600 CALIFORNIA STREET
FEDERAL HOME LOAN BANK OF SAN FRANCISCO
ENVIRONMENTAL IMPACT REPORT

FINAL

-
- CHANGES FROM THE TEXT OF THE DRAFT EIR ARE INDICATED BY SOLID DOTS AT THE BEGINNING OF EACH REVISED SECTION, PARAGRAPH, GRAPHIC OR TABLE.
-

FIGURE 3
GROUND FLOOR PLAN

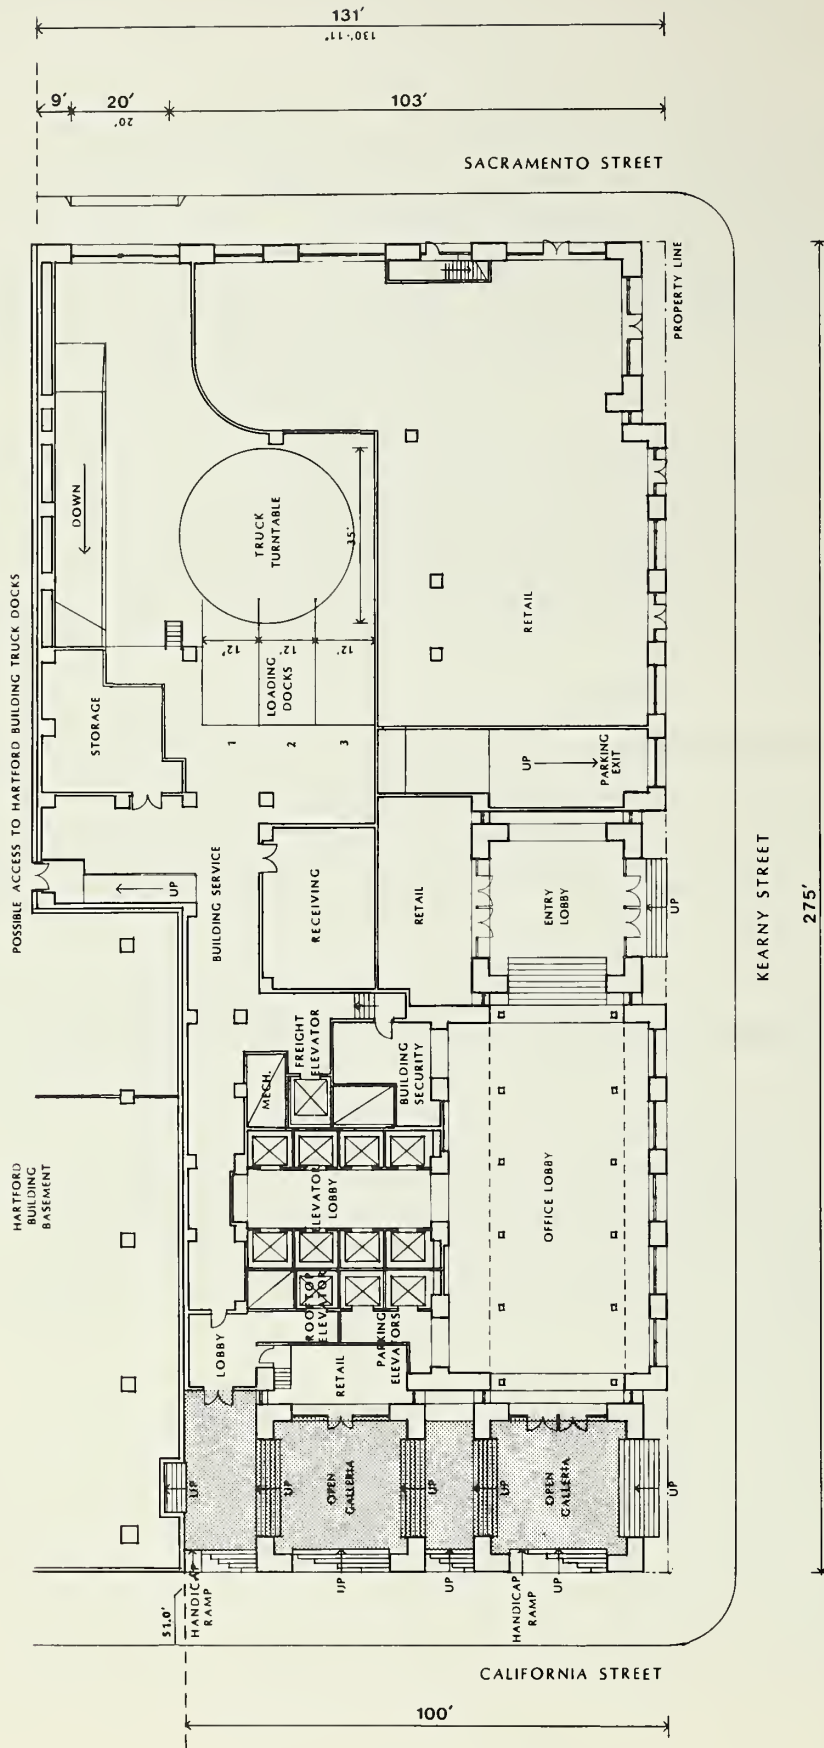
Figure 3, p. 25, of the DEIR shows the entrance to the parking garage and loading docks as 20-ft. wide. The DEIR project and this figure have been revised to widen the curb cut by about three feet on the eastern edge, reducing the wall width, labeled 'Down' in the DEIR figure to ten feet (it is 12 ft.-wide in the DEIR figure) and moving the eastern wall which leads to the truck turntable, about three feet further east. As shown (on revised Figure 3, p. 251 herein), the entrance to the parking garage and loading docks could adequately accommodate 40-ft. trucks without back-up maneuvers, therefore reducing potential queuing problems on Sacramento St. There could be conflicts between cars entering the garage and trucks entering or exiting the loading docks if more than one truck were entering or leaving; during the one to two minutes it would take for a truck to make the forward movement into the loading dock; or if the truck turntable were to break down, requiring trucks to back out of, or into, the loading dock. This could result in a one- to two-minute delay for cars entering the garage and a corresponding one- to two-minute backup and possible queuing along Sacramento St.

One truck turntable is proposed for the three loading spaces as shown in revised Figure 3, p. 251, herein. As noted on p. 123 of the EIR, the turntable would enable trucks to enter the loading area in a forward motion, without backing-up onto Sacramento St. The turntable would eliminate truck loading impacts on Sacramento St. except if and when the truck turntable were to break down as noted in the response on p. 250 herein.

FIGURE 31A – ALTERNATIVE E2: BUILDING HEIGHT OF 50 FT. ALONG SACRAMENTO STREET (RANGING FROM ABOUT 47-60 FT.) WITH A 60-FT. DEEP SETBACK ABOVE AND ALTERNATIVE PARKING SCHEME

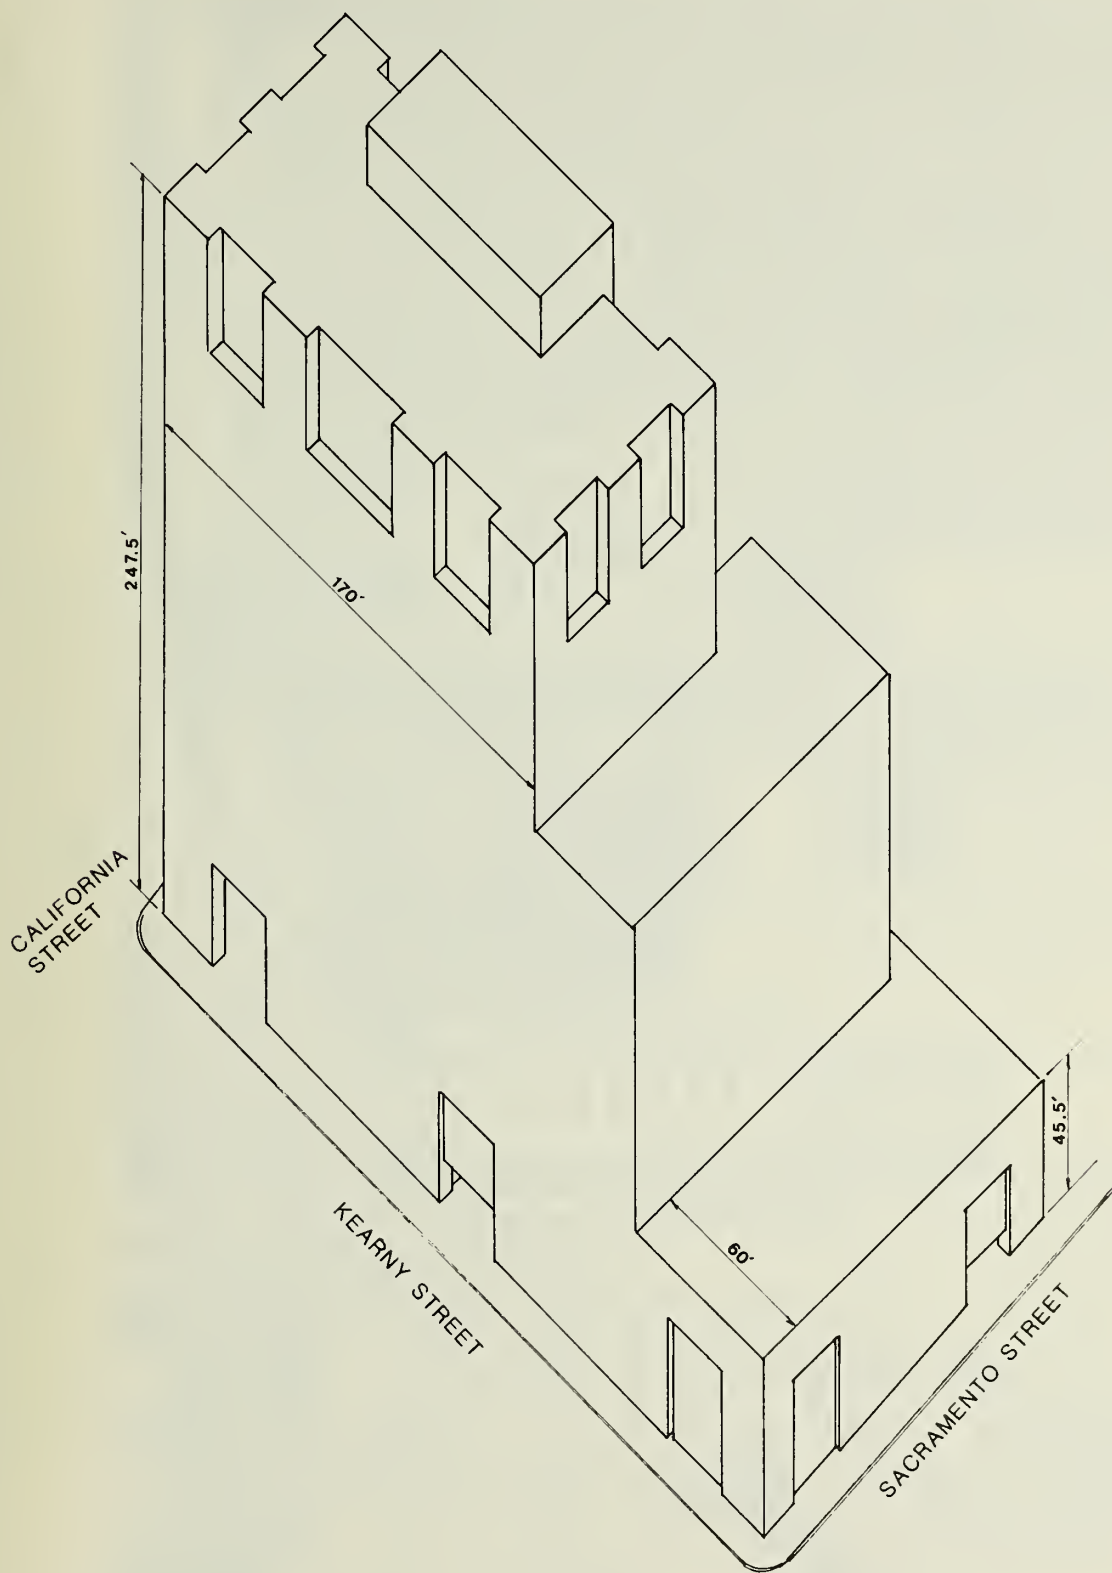
Figure 19, p. 83 of the EIR, shows the Sacramento St. frontage, including the 45 ft.-tall portion of the project, and Figure 18, p. 82 shows a view of the project west up Sacramento St. These photomontages show that this portion of the project would not be noticeable from these viewpoints. As noted above, more photomontages of the project at street level will probably be prepared later in the process when more precise plans are available. The 45-ft. portion of the DEIR project may not be shown in greater detail if Alternative E becomes the preferred alternative.

Figure 31A, p. 290 herein, shows a schematic drawing of Alternative E2. Figure 31B, p. 291 herein, is a photomontage of Alternative E2.

This alternative would be of similar design to Alternative E1 discussed on pp. 158 to 161 of the EIR except that it would step up in three steps instead of two from Sacramento to California on the Kearny St. frontage. This alternative would range from about 47-ft. at the west property line to about 60-ft.-tall at Sacramento and Kearny Sts. with a 60-ft. setback above. The building would step up from 50 ft. to about 146-ft.-tall, along the Kearny St. frontage about 60-ft. south of Sacramento St., then step up again to about 240-ft.-tall about 150 ft. south of Sacramento St. (See Figures 31A and 31B, pp. 161a and 161b [pp. 290-291 herein]). The 240-ft.-tall portion would not be

FIGURE 31B
PHOTOMONTAGE OF ALTERNATIVE E2
FROM SACRAMENTO/WAVERLY INTERSECTION

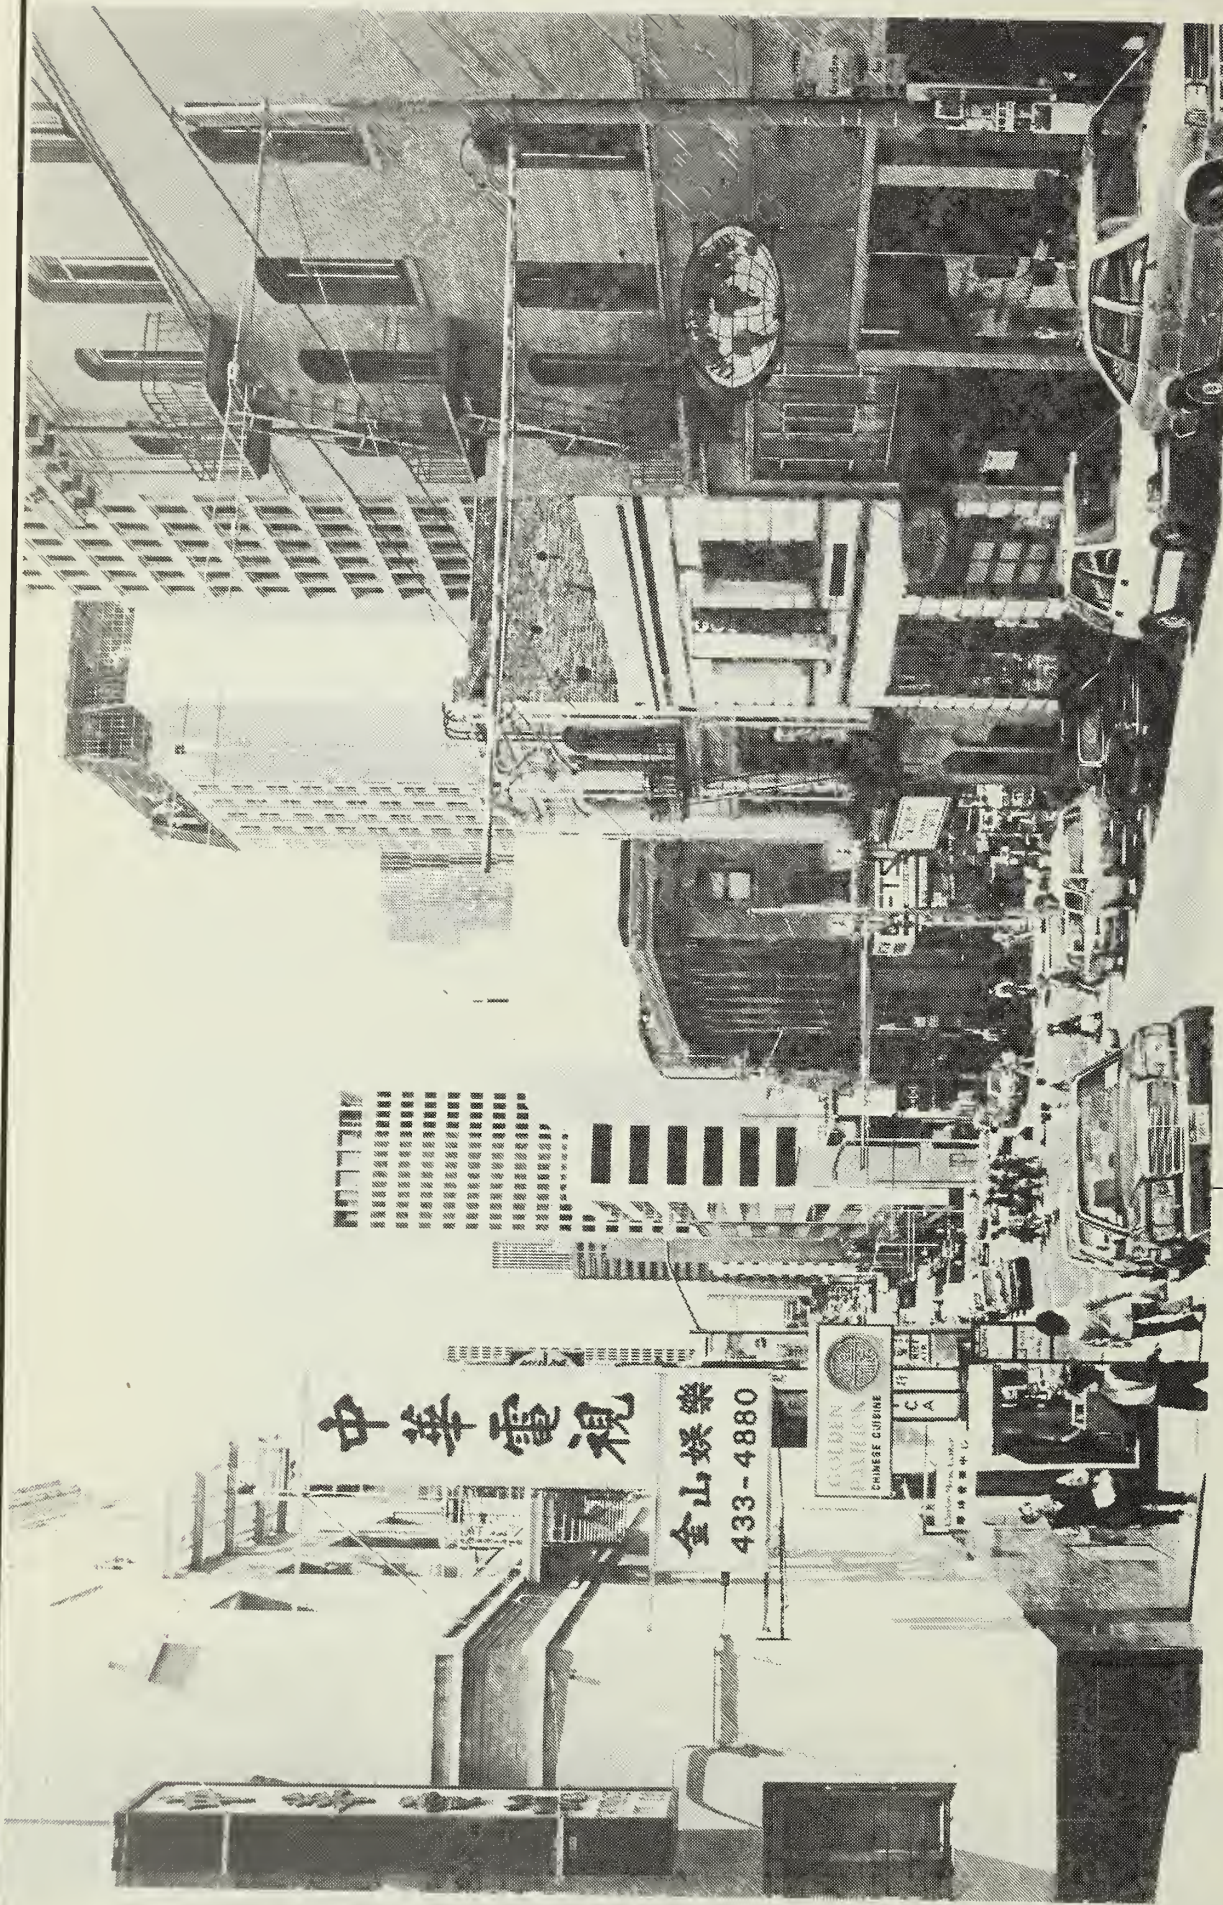
"Photos do not show useful views of scale impacts of proposed project as viewed from Chinatown locations. Show project in photomontage from Grant and Sacramento, Kearny and Commercial, Sacramento between Grant and Kearny (north side) and from each location and angle used in Figure 9, 10, 11, and 12. Show also photomontages of Alternative E from these locations." (Gordon Chin, Chinatown Resource Center)
